WEDGWOOD CENTER DEVELOPMENT

Early Design Guidance - 2

SDCI # 3040032-EG

10/28/2024

Massing Concept C looking Northeast

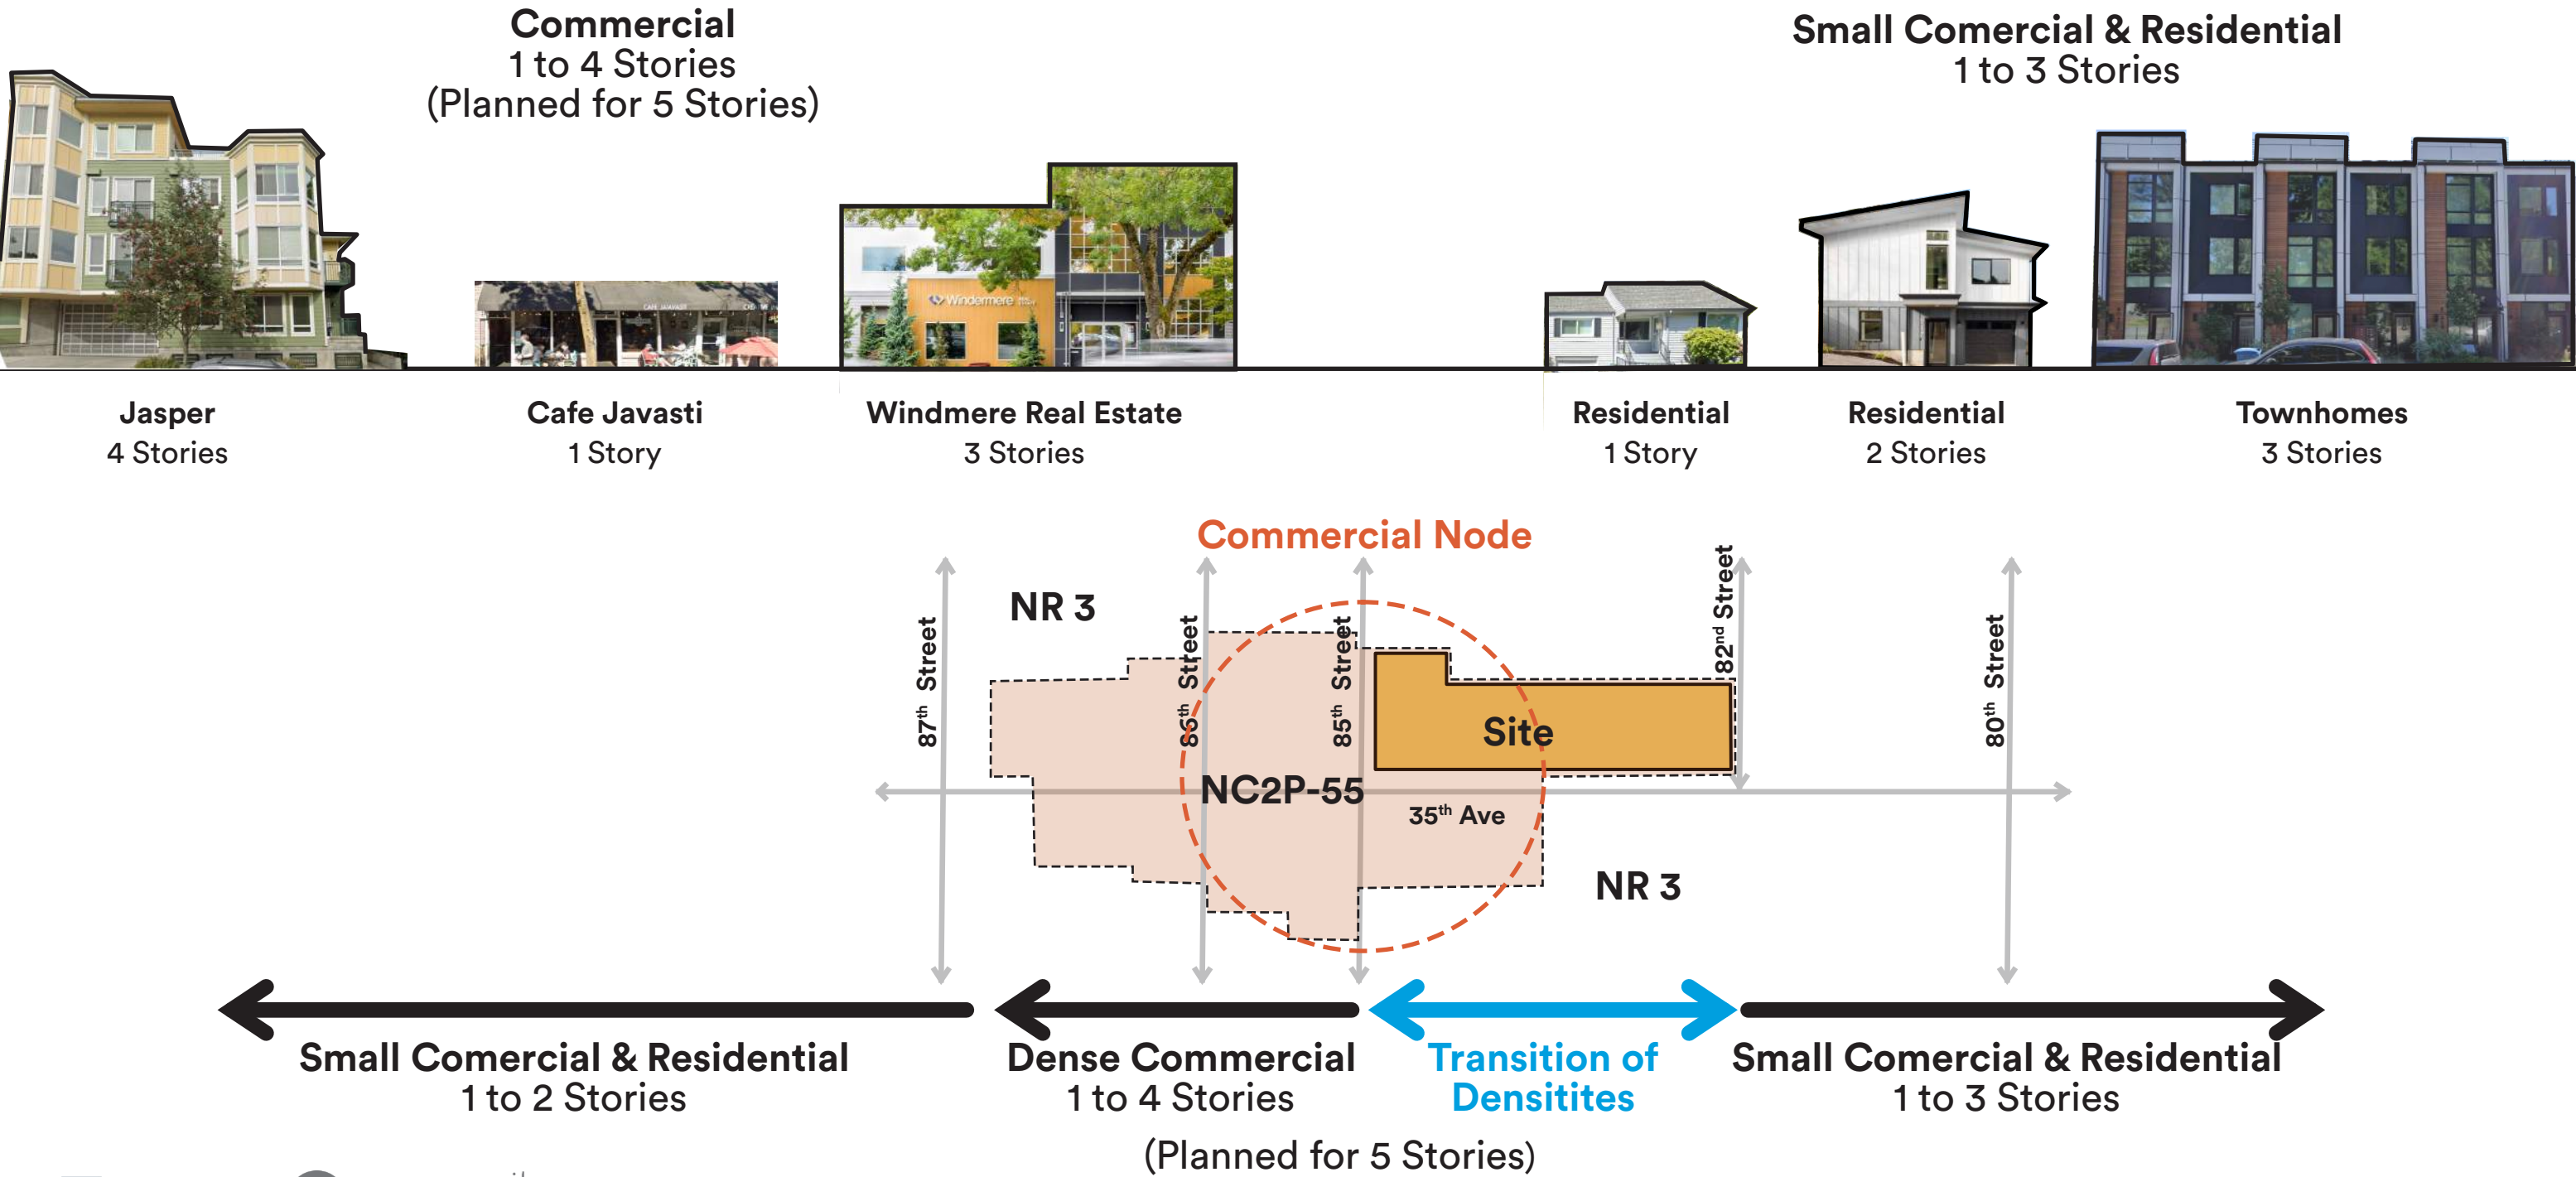
B. **Support** for massing Concept C, but **request** for further study of massing of the buildings to reduce the perceived scale and fit the context of the neighborhood better

The Board unanimously supported the applicant’s preferred massing, Concept C. Noting that the building would most commonly be viewed from north or south from 35th Ave NE, the Board supported the three-part massing, with additional modulations, that creates the appearance of a series of smaller buildings along the long block. The Board requested further study to ensure the perceived scale is appropriate to the neighborhood context.

Concept Diagram

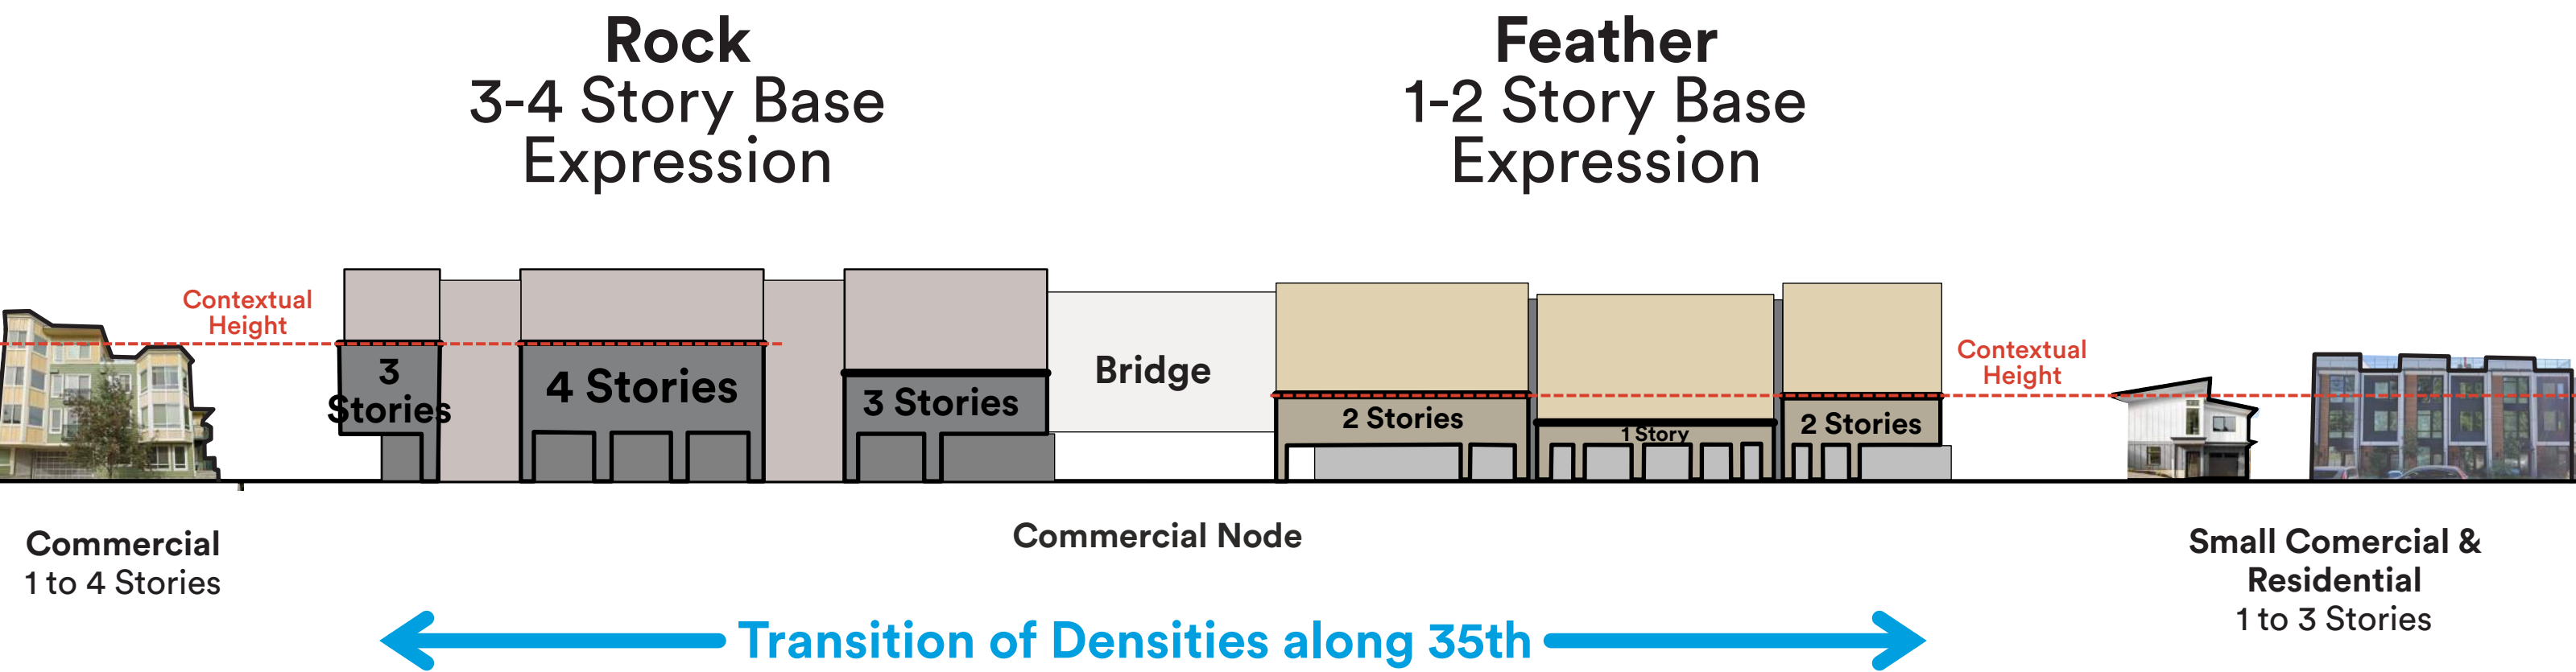
B. **Support** for massing Concept C, but **request** for further study of massing of the buildings to reduce the perceive scale and fit the context of the neighborhood better

The design team refined the architectural expression of Concept C to address the transitional nature of the block more effectively with a 4 story base expression at the corner of 35th and 85th stepping down to a 1-2 story base expression nearer 82nd St, creating a sense of neighborhood-focused scale from the commercial to the residential zone. The ‘rock’ form is intended to create a solid center for the community of Wedgwood, while the ‘feather’ is intended to further break down scale and incorporate color schemes which lead to this portion feeling lighter & smaller in scale.

Perspective of Northwest Corner at 35th and 85th

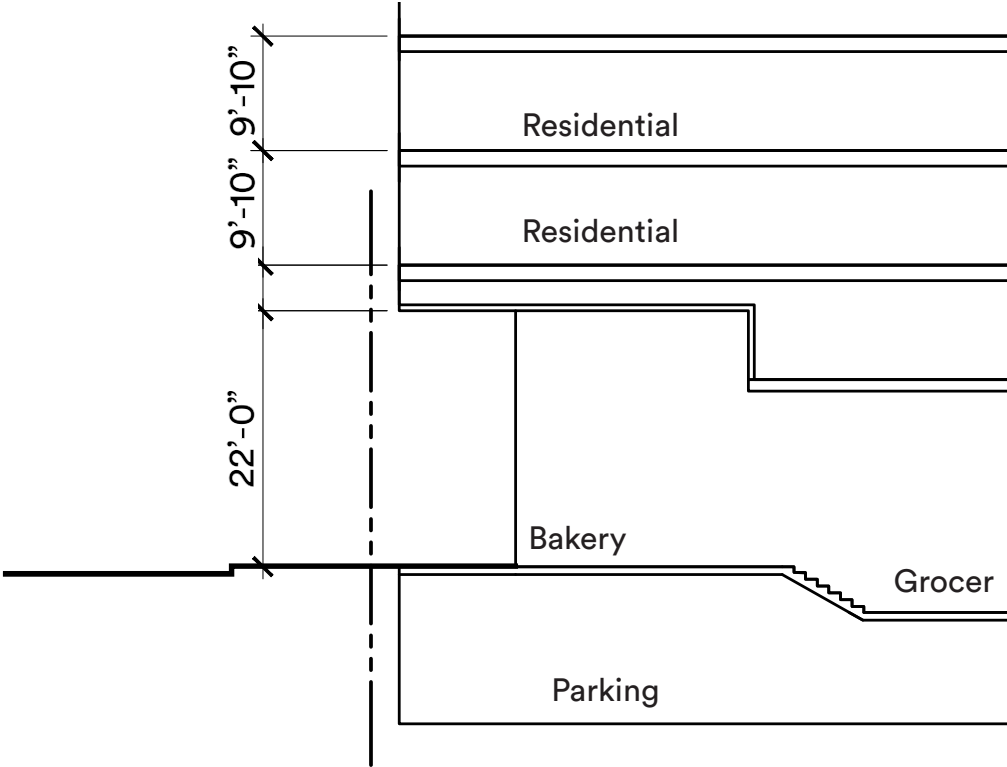
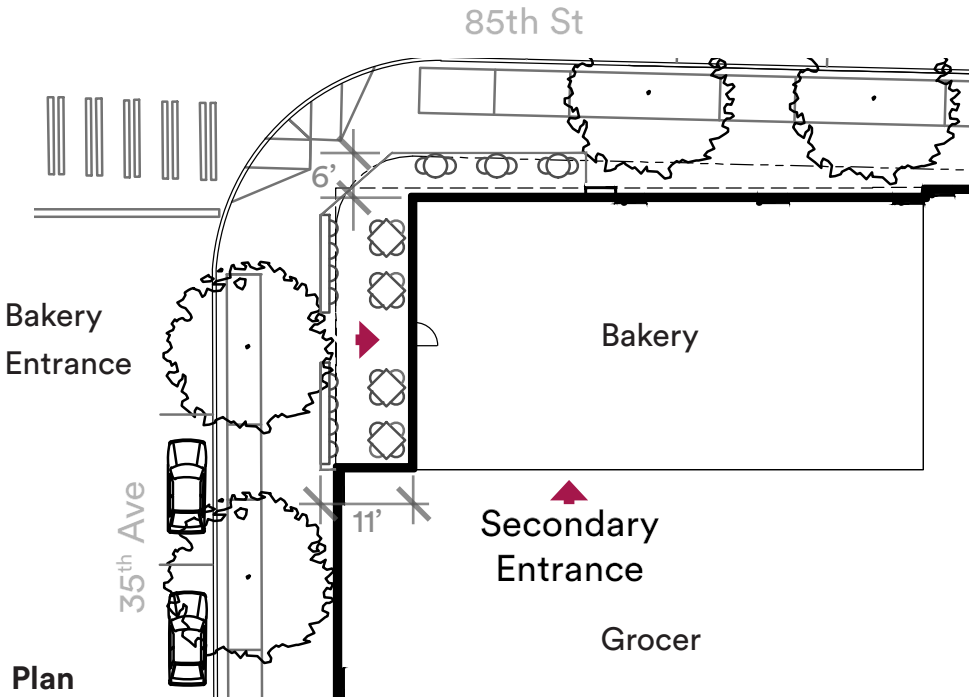
B. **Request for** more study of the NW building corner to encourage engagement and activation

The Board noted that development of the northwest corner of the building is an important opportunity to set design precedent at the important neighborhood commercial node noted in the Wedgwood Vision Plan. The Board questioned the notched-in ground floor that did not correlate to the building form above, creating a fully covered space. The Board requested studies to show how the design of the building and site will activate the corner.

The design team studied several alternative massing options at the corner, described below:

- Holds corner back, creates a sightline
- De-emphasizes corner expression, diminishing the corner commercial use
- Provides open-to-the-sky outdoor space with seasonal limitations, and relies on retailer to provide site furniture

- Inset massing creates strong presence
- Covered space provides outdoor seating and shelter from rain

- Creates a visually strong and unique architectural expression at the corner
- Covered space provides outdoor seating and shelter from rain
- Building Access and outdoor space orients toward 35th Ave

EDG 1 Concept C Site Plan

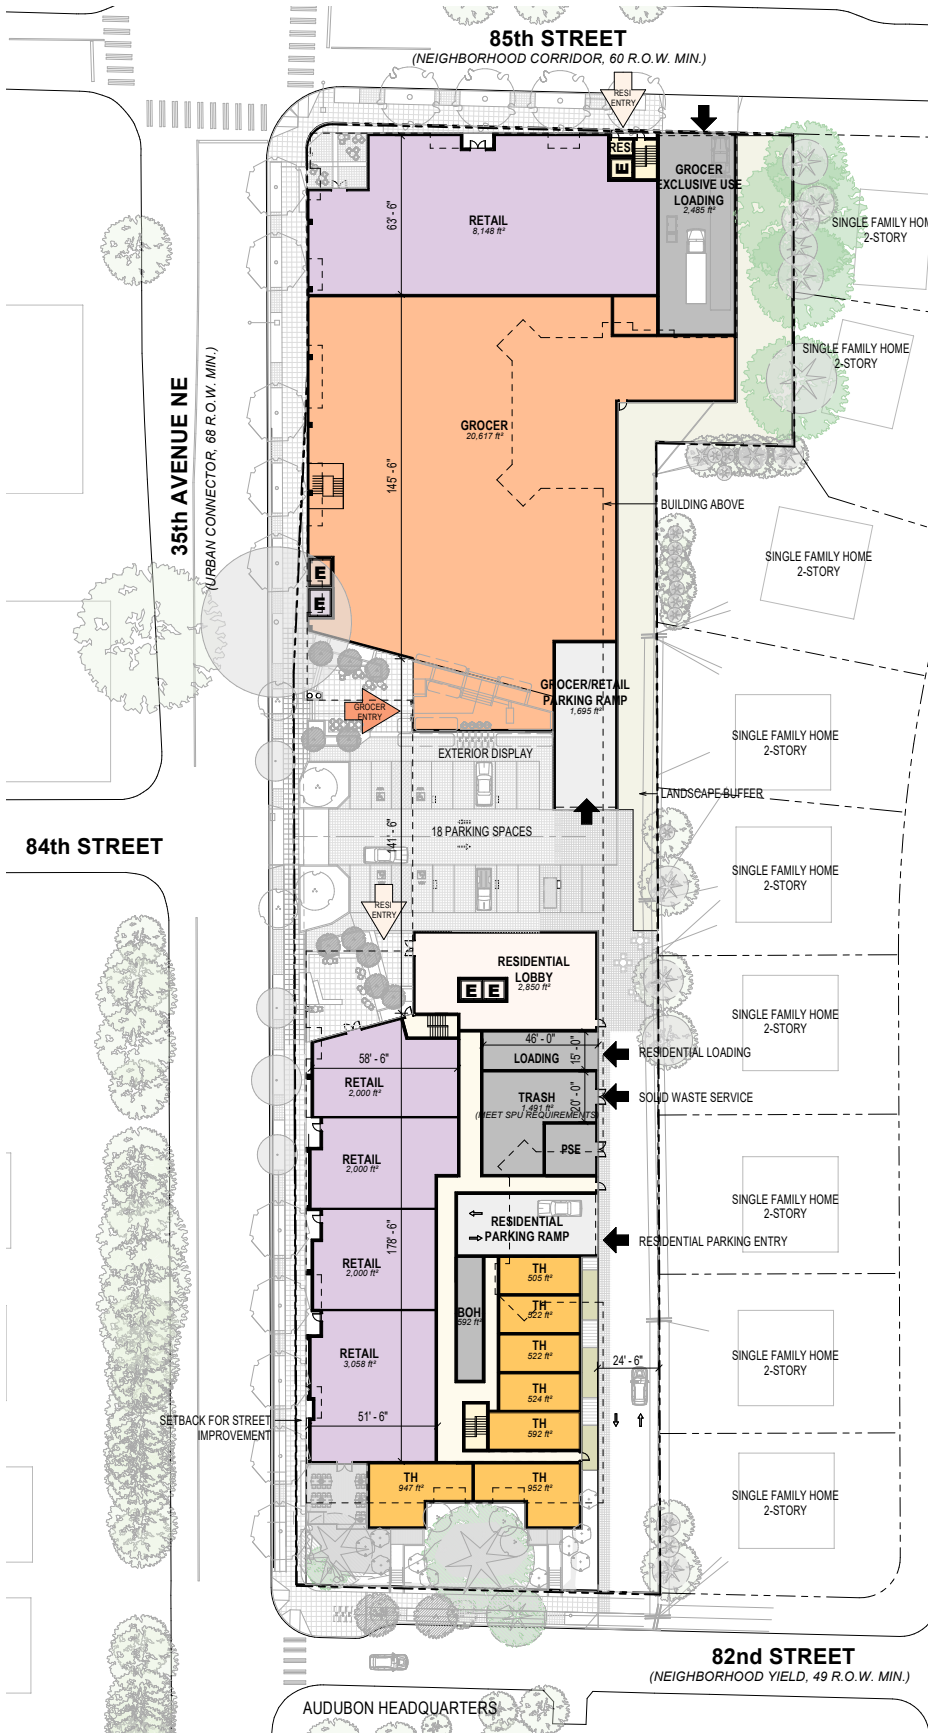
- B. **Request for** further study of circulation options at the Mid-block Court
- i. Retain vehicular access but remove surface parking
 - ii. Revise access to one-way only
 - iii. Remove all vehicle access and parking and design Court as pedestrian only
 - iv. Request for study of access to the grocery store from the north side of the site in lieu from the center

The Board discussed the curb cut access at 35th Ave NE and surface parking of Concept C at length. They voiced concerns regarding pedestrian safety as well as opportunities for pedestrian activation with active vehicle circulation crossing the sidewalk and in the ‘plaza’. They questioned whether on-site surface convenience parking was necessary as there is available street parking. There was a further suggestion to include a retail unit to enclose the east side of the gathering space that could add further activation of the space.

The applicant understands the concerns and has studied several options which aim to maximize pedestrian safety while remaining cognizant of the requirements necessary for a grocer tenant to occupy the prime Retail.

Study 1:
Pedestrian Plaza,
Vehicle access from 85th

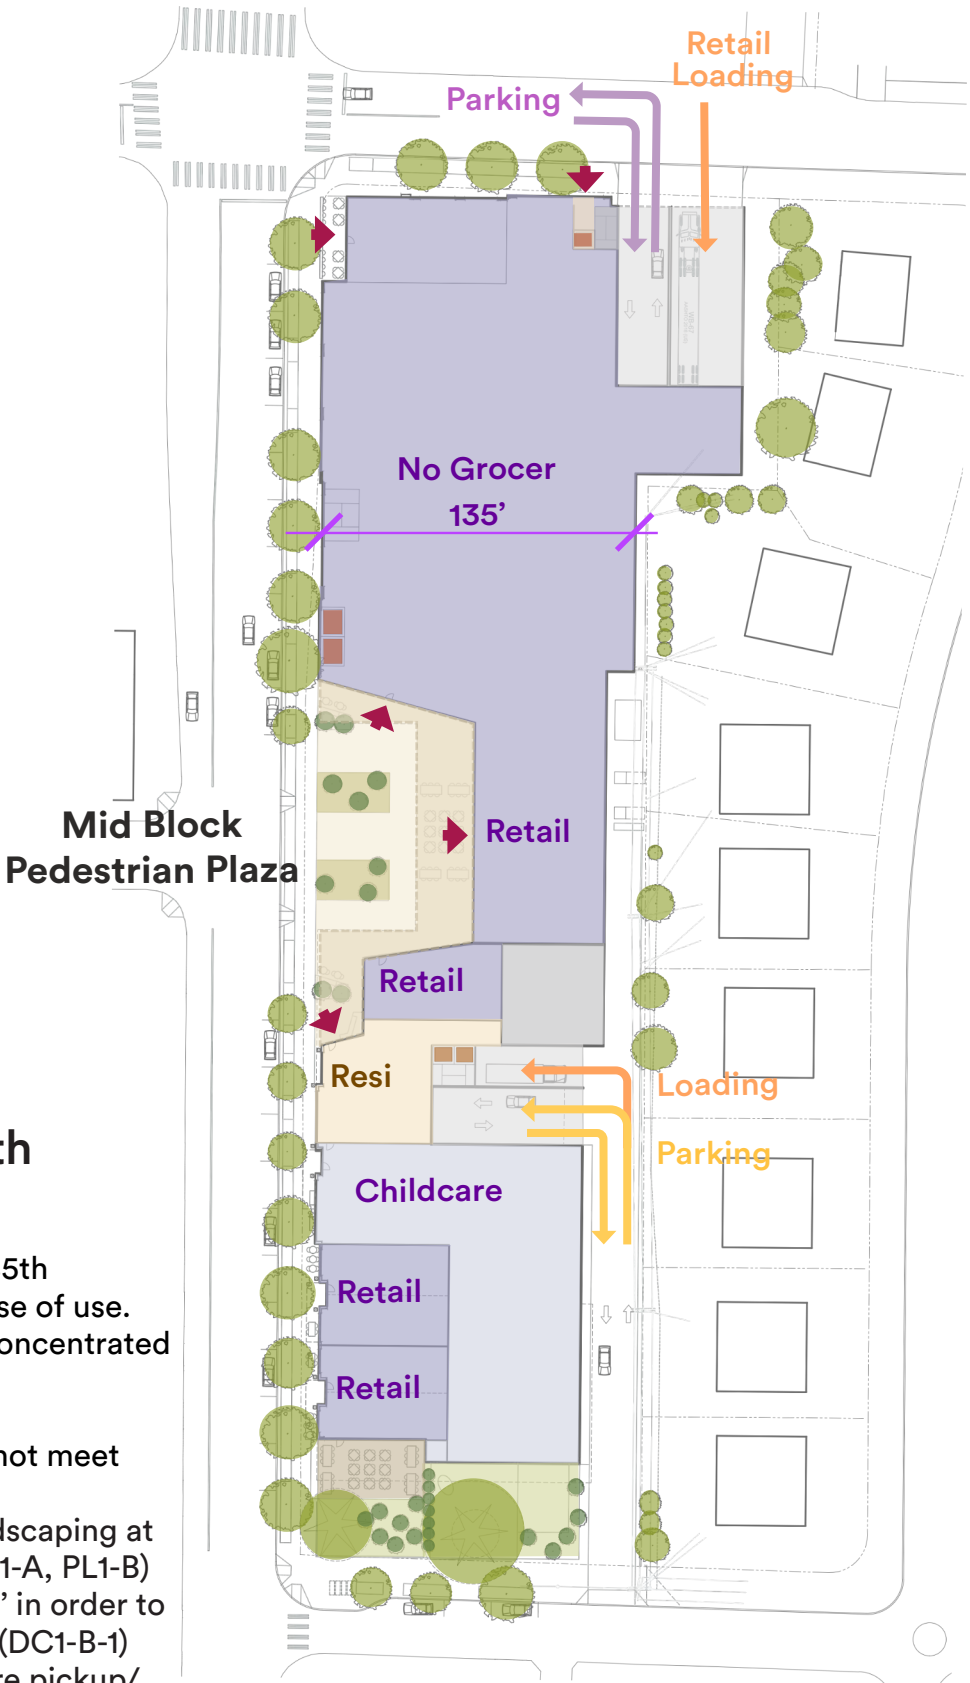
B. Request for further study of circulation options at the Mid-block Court

- Mid Block Plaza is pedestrian only
- Vehicle access into retail moves to 85th
- North retail reaches too deep for ease of use.
- Northern retail provides too much concentrated retail SF for the neighborhood.
- Retail depth is not feasible.
- No grocer. Parking & circulation do not meet requirements
- Maximized outdoor seating and landscaping at Mid Block Plaza (PL3-A-B, PL3-2, PL1-A, PL1-B)
- Curb cut along 85th is too wide at 55' in order to provide adequate pedestrian safety (DC1-B-1)
- No convenience parking for childcare pickup/drop off
